TECHNICAL MEMORANDUM

PROJECT #: 727.07 Task 01 (P19-0061)

SUBJECT: Artz Wetland Revised Report Review

Figure 2. City of Puyallup mapping, showing wetlands, streams and floodplains.

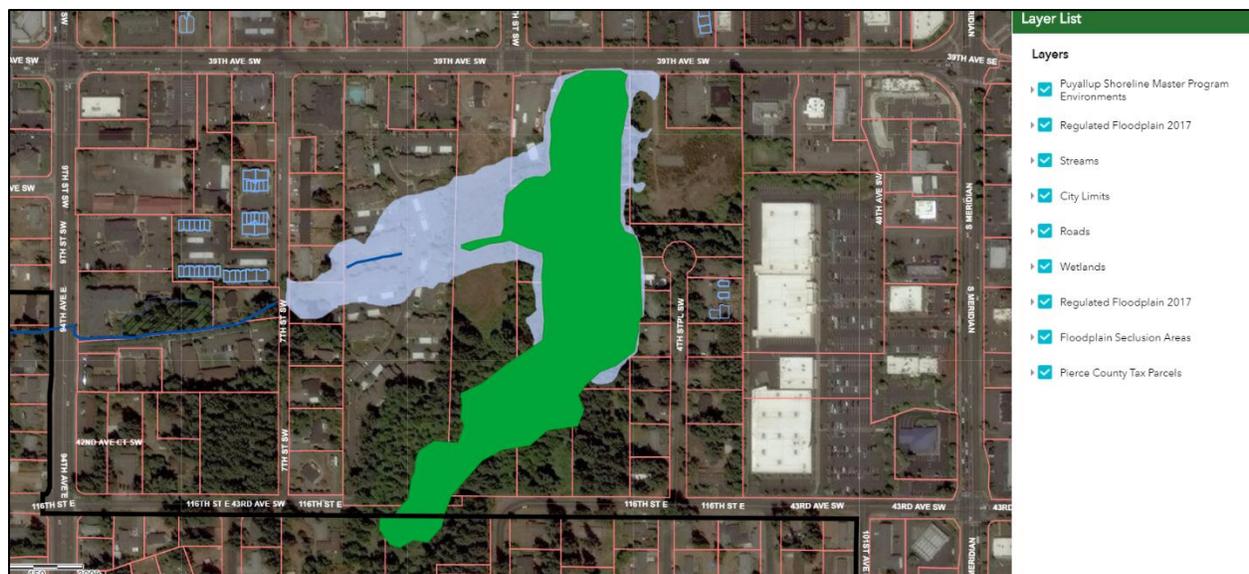
- Please provide a topography base map for future site plan submittals.
- Ideally, the report figures would also include the Floodplain mapping, as depicted in Figure 2 below, but as the development does not infringe on the floodplain, the lack of this Figure in the report is acceptable.
